TO: Public Works and Environmental Concerns Committee
FROM: Carl S. Goldsmith, Director of Public Works *CJ*
DATE: October 18, 2016
SUBJECT: Village Standard Lighting Policy

Subject: Street Lighting Policy **Section:** 6.C.
Dept.: PW
Date: October 2, 2003
Updated: November 8, 2016

Village Standard Lighting

December 2010 October 2016

Residential Street Lights Concrete Flared Base Poles

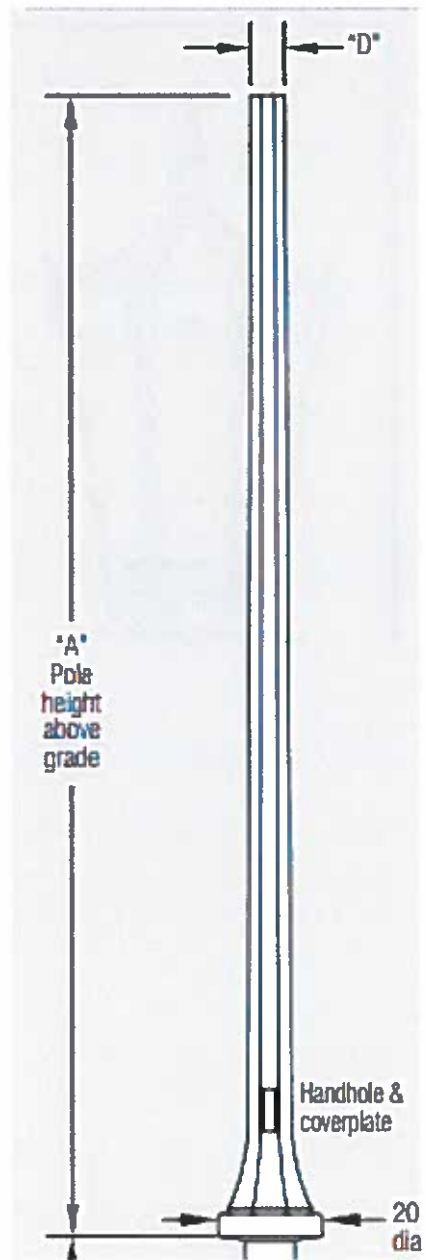
- Eliminate HPS for installation option
- Eliminate concrete straight base poles as an option for older sections of town when maintenance is performed and use concrete flared base poles as the standard for new/replacement installations

- Incorporate IDOT standard Specifications from 2012
- Define manufacturer and models for concrete flared base poles
- Define manufacturer and models for concrete straight base poles
- Eliminate the HPS Ornamental Luminaire as an option

Ameron Centrecon VEM-4.6

Stresscrete KS15

**Roadway Luminaire
Cobra Head LED**

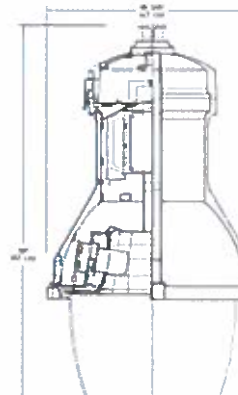
- LED Cobra-head only option for new installations

- Eliminate the HPS Decorative Downlight Luminaire as an option
- Eliminate the HPS Ornamental Bracket Mounted Luminaire as an option
- Add Section 1067 to provide an LED standard for Cobra-Head Roadway Luminaire

American Electric Autobahn ATB2 60B

Cooper Lighting Navion NVN-AA-04-E-U-SL2

General Electric Evolve ERs3-MX-BX-5-40-4-Grey
